HILLSIDE NURSERIES, BURY

ECE Architecture

PLANNERS' FEEDBACK OF INITIAL SCHEME

INITIAL COMMENTS TAKEN AT THE PRE APP MEETING WITH THE PLANNERS

PLANNERS' FEEDBACK OF CURRENT SCHEME

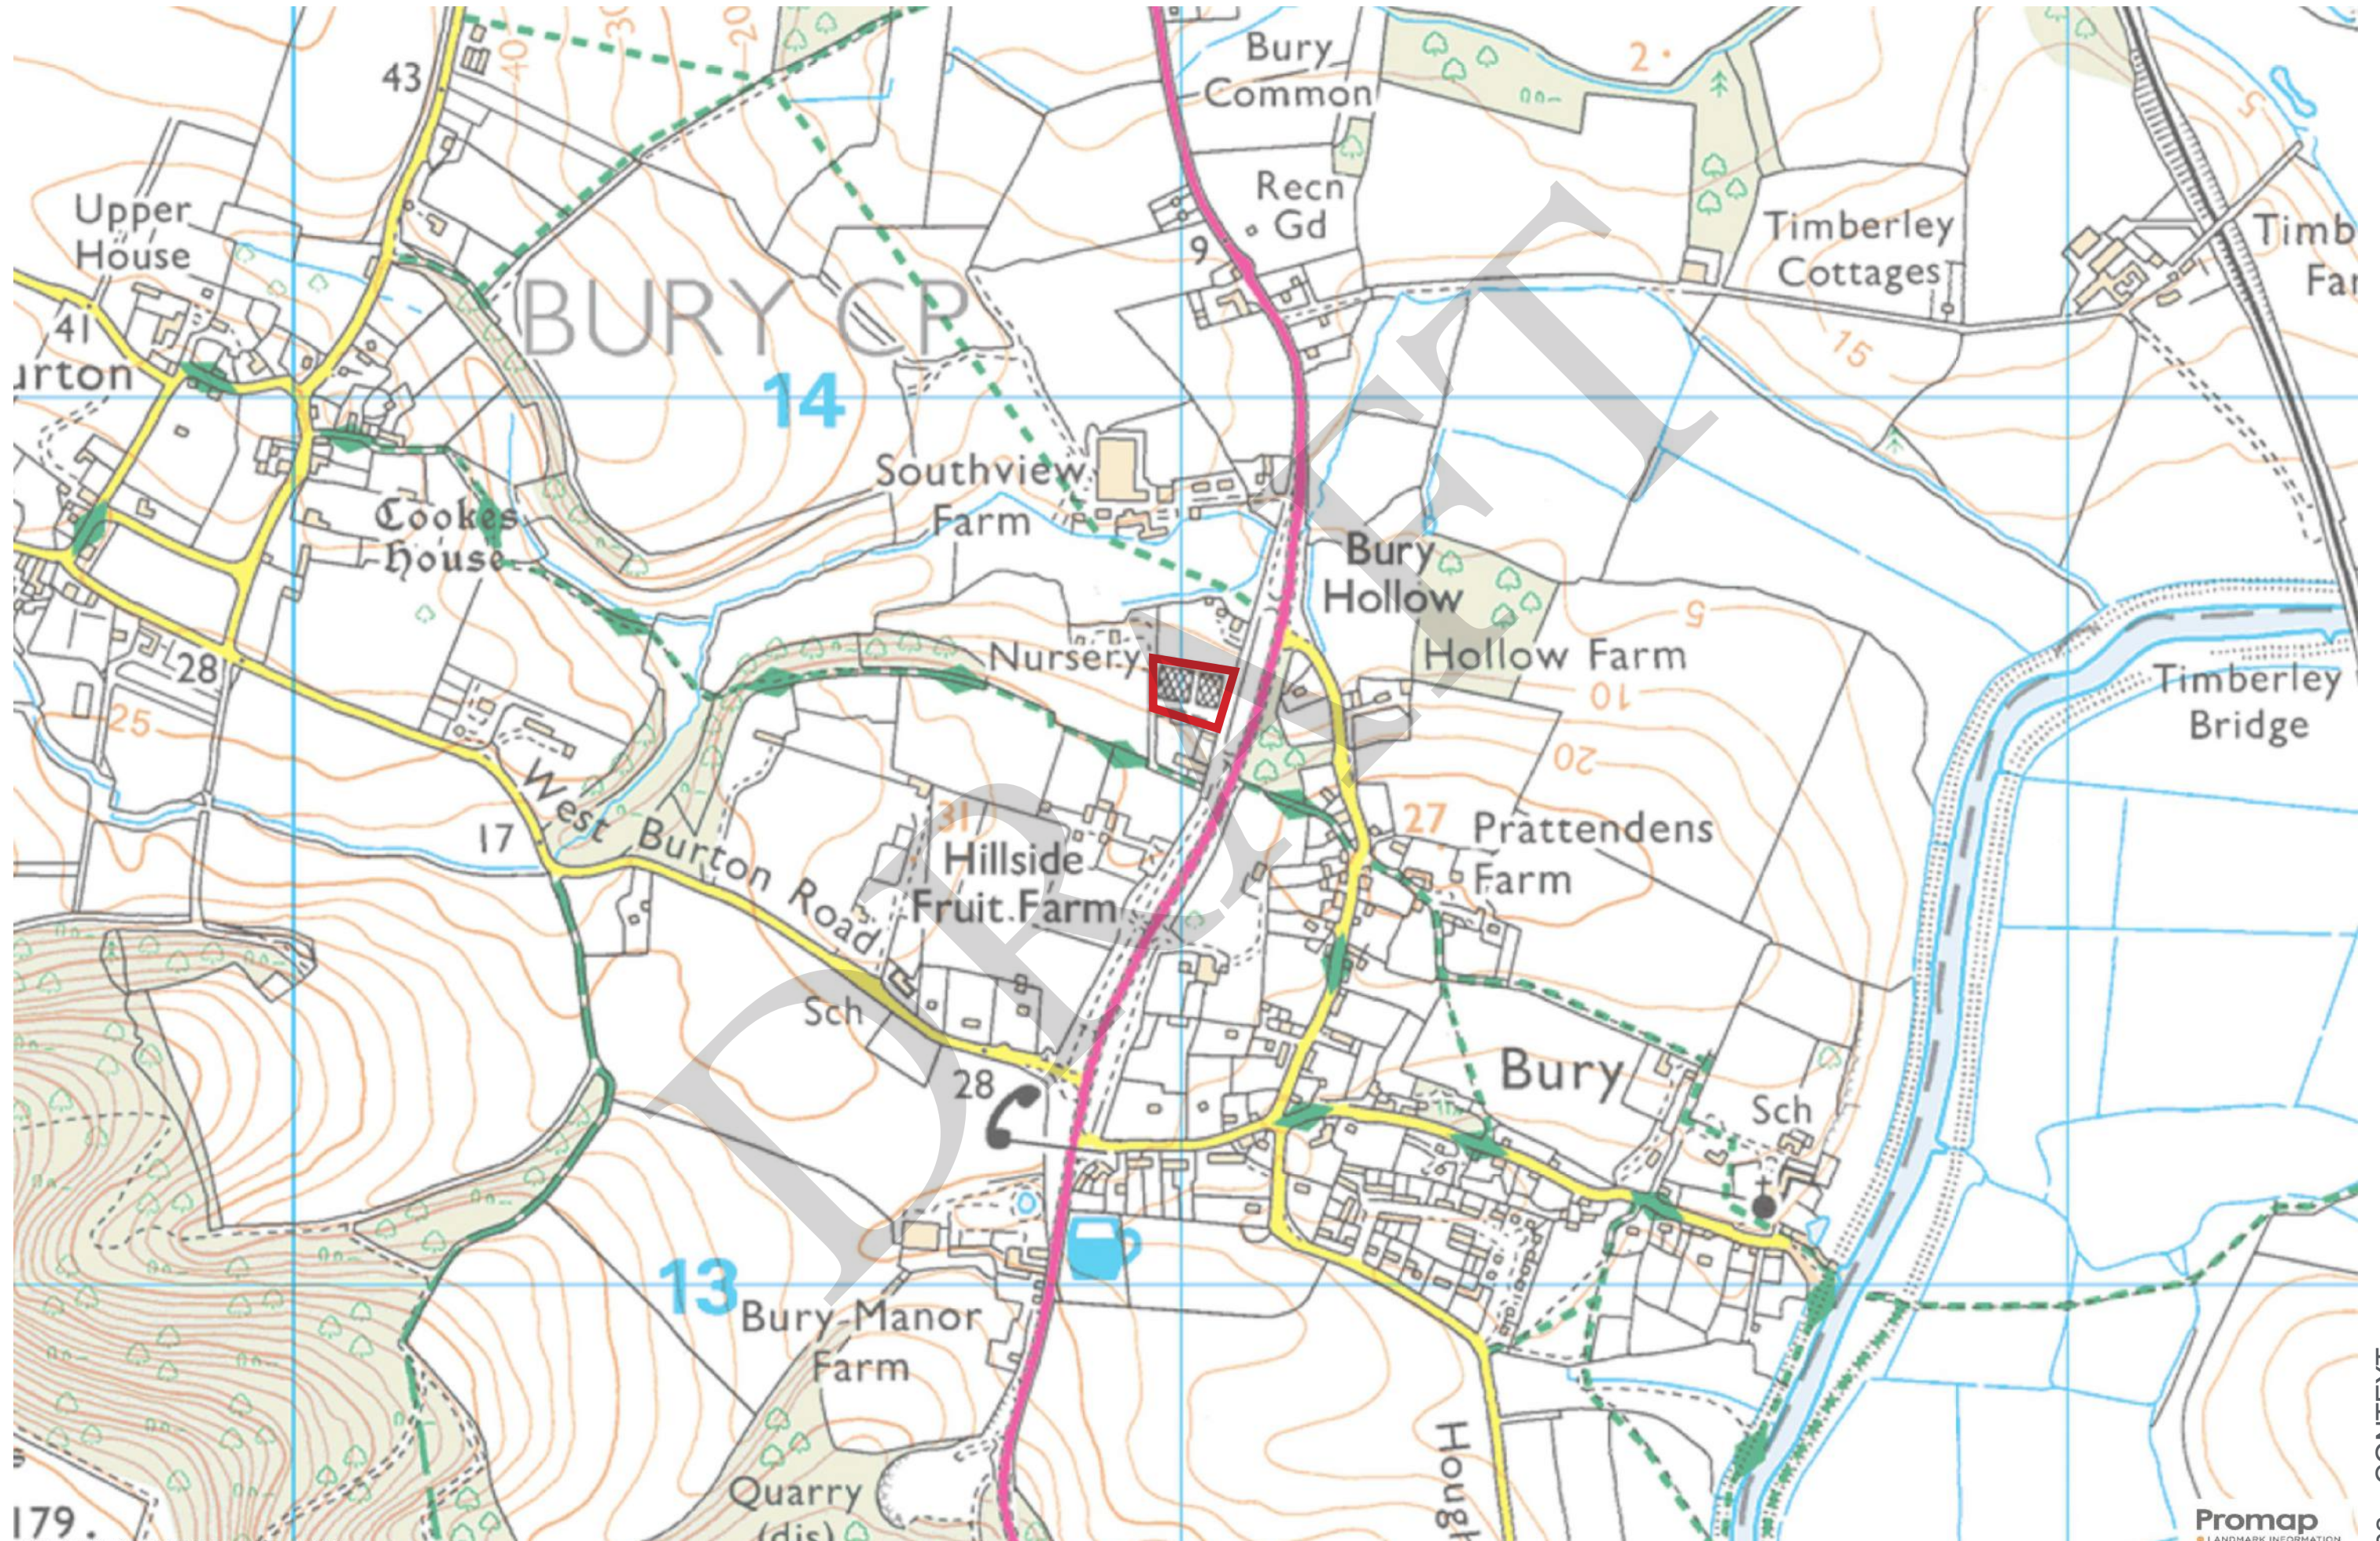
- What is the character of the site?
- What is the inspiration behind the scheme, what's holding it all together? Any nods to the long-established horticultural heritage?
- Layer up constraints and opportunities rather than displaying one plan. Lack of explanation
- Adopt the incidental, ad-hoc informal characteristics that are typical of this area

Rectilinear yard more appropriate than hammerhead

Development too close to sensitive boundary

Make use of on-road informal parking opportunities

Meaningful green and blue infrastructure to be integrated into the site before plot division

No pedestrian connection to 'Coffin Trail' PRow at rear

Should be larger gaps between buildings to reflect local pattern

Site Contours (show) - change as little as possible, build into them, use them for surface water conveyance across site

Commercial buildings should address the road

Single vehicular access to reflect local character

Commercial space should take priority on the site. Also shouldn't be dominated by parking, provide quality amenity

Isolated and tightly packed water elements, should continue through site

In an area where routes are typically straight it may be that a straight route with properties laid out and designed more organically using the contours

In part relying on affordable housing for acoustic mitigation - rotate to face the drive or use commercial?

Change density across the site - mid to high density centre/front, lower density toward sensitive rear field / PRow

UPDATED SITE PLAN RESPONSE TO PLANNERS INITIAL COMMENTS

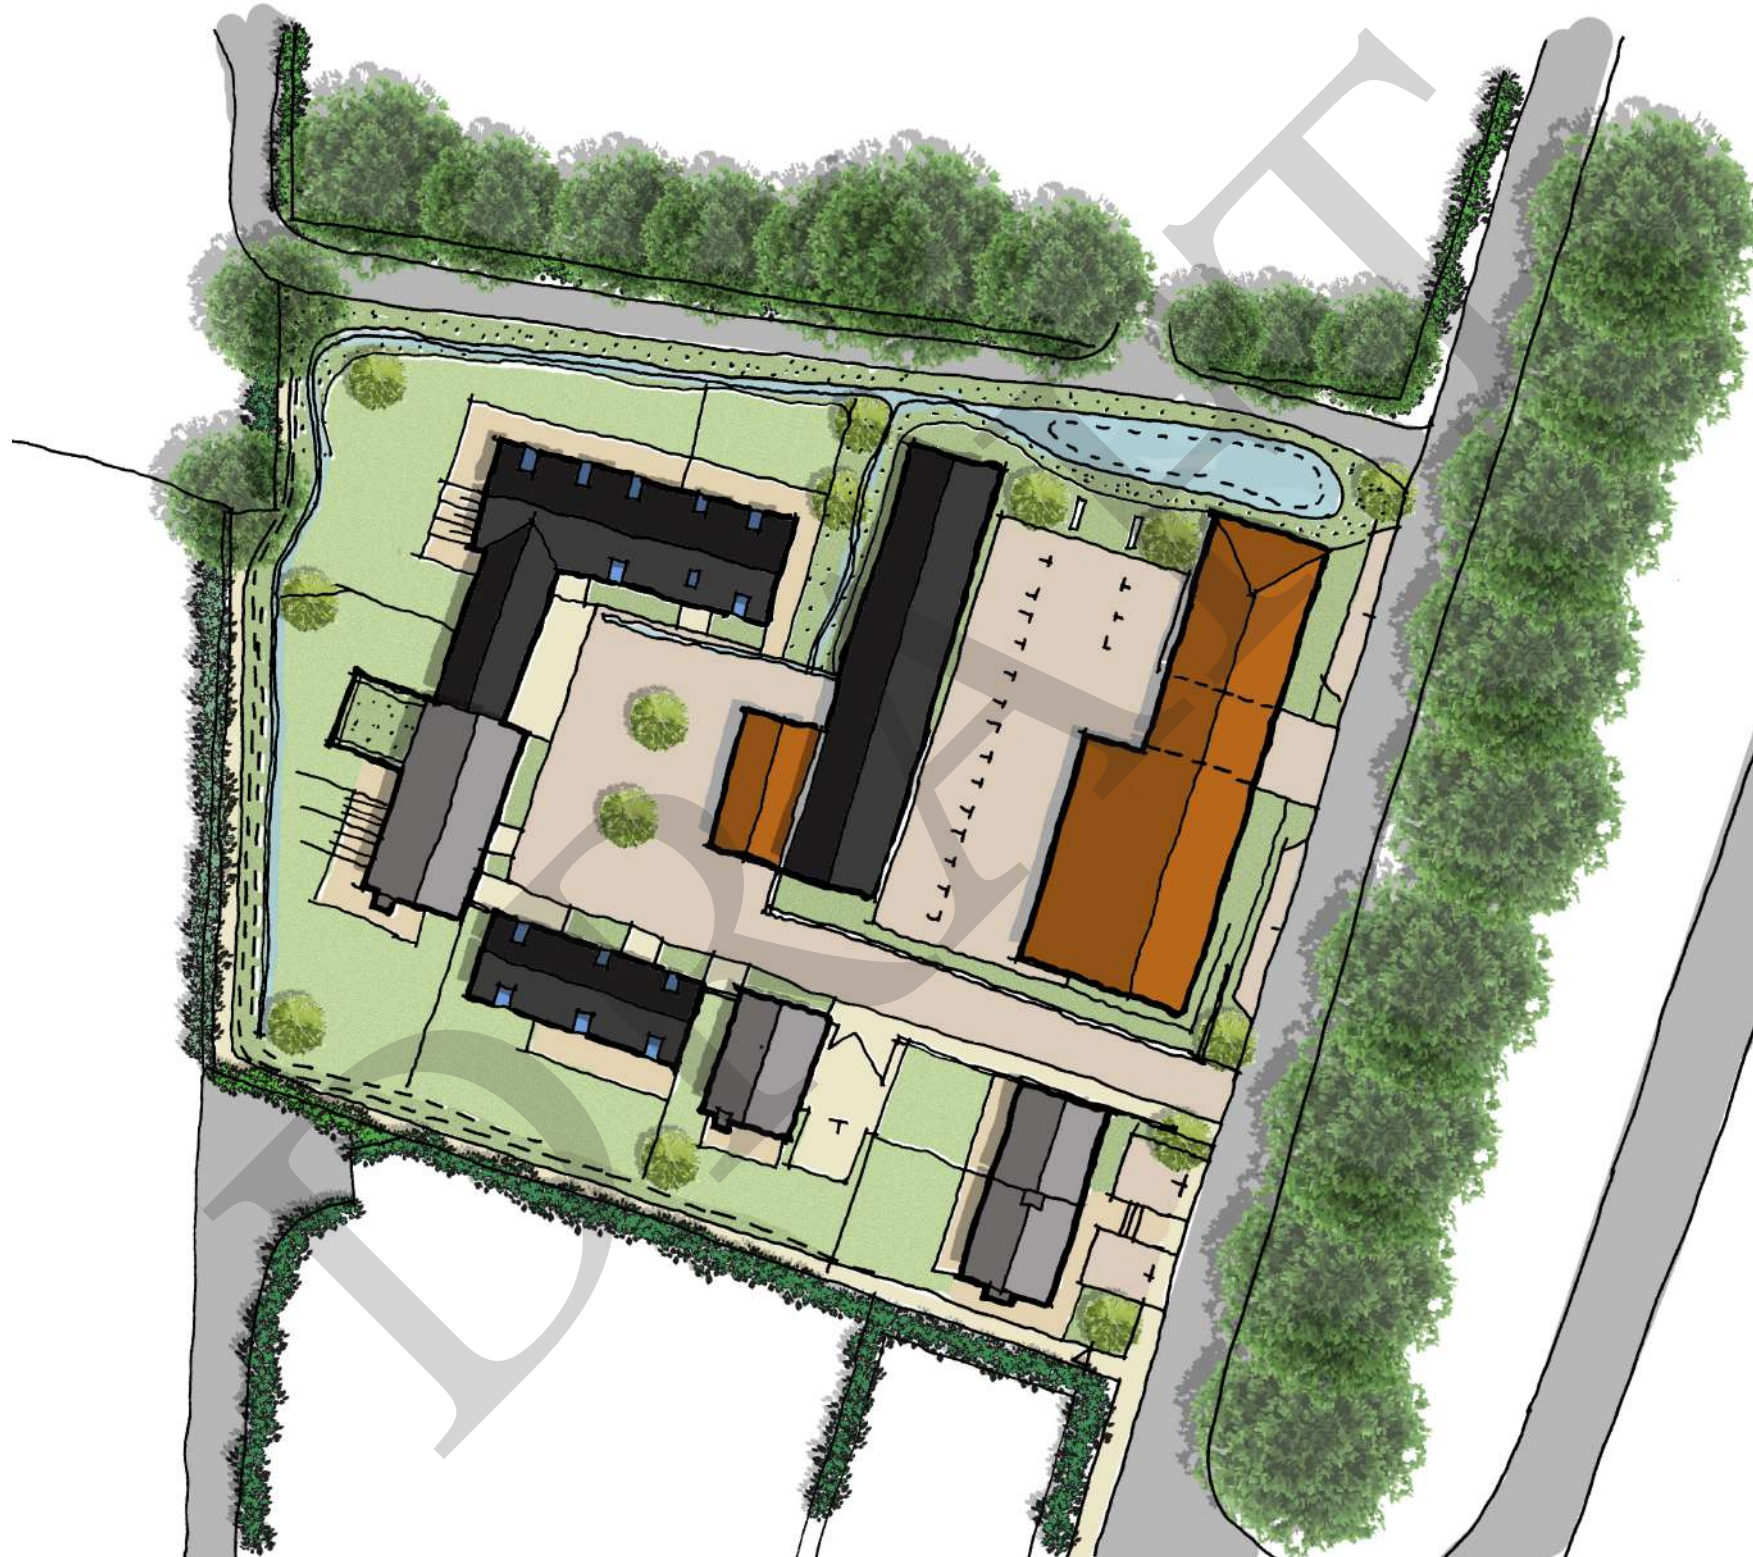
2. Provide a landscaped buffer to the northern edge not a timber fence. Include a swale detail along the road edge as part of the green infrastructure strategy.

3. Towards the north east edge maybe provide a more open corner to the site in and around the attenuation pond.

5. Farmstead Typology and character of the site commended.

6. Referencing the nuances of Bury would add merit to the scheme.

7. LVIA scoping and mythology and evidence clearly helped to inform this new layout.

8. The current layout could be less ridged and more organise and less formal, a sense of historic ad-hoc design, developed over time.

23. More detail required on how the site responded to the existing levels on site.

24. More detail required on the roof line of the development when viewed from Coffin Way.

1. Maintenance strip added
2. Landscape buffer and swale added. Discussions required with neighbour on extent of proposed privacy timber fence
3. low level landscape buffer to the north of the attenuation pond

4. Field pattern used as part of the green and blue infrastructure
5. Farmstead Typology and character of the site retained and strengthened
6. Referencing the nuances of Bury would add merit to the scheme. TBC

15. Parking for the cottages moved to the side with a single entrance walled courtyard and rear access
16. Opportunity to create a contemporary development based on the contextual analysis of Bury. TBC
17. Green roof - Added to development.
18. Passive House - ECE to provide options for a passive standard not accredited using traditional construction.

ECE to review existing energy statement and provide comments with new layout.
19. Sustainable design strategy required, ASHP and PV panels. Individual (residential) and combined (commercial)
20. Bin storage and cycle storage to be integrated into the design of the houses and the commercial spaces
21. On street parking to add to visitors spaces.
22. Parking strategy required.
23. More detail required on how the site responded to the existing levels on site.
24. More detail required on the roof line of the development when viewed from Coffin Way.
25. Review layout and size of houses. make a 4 bed a 4bed, not a 4-bed with a large study
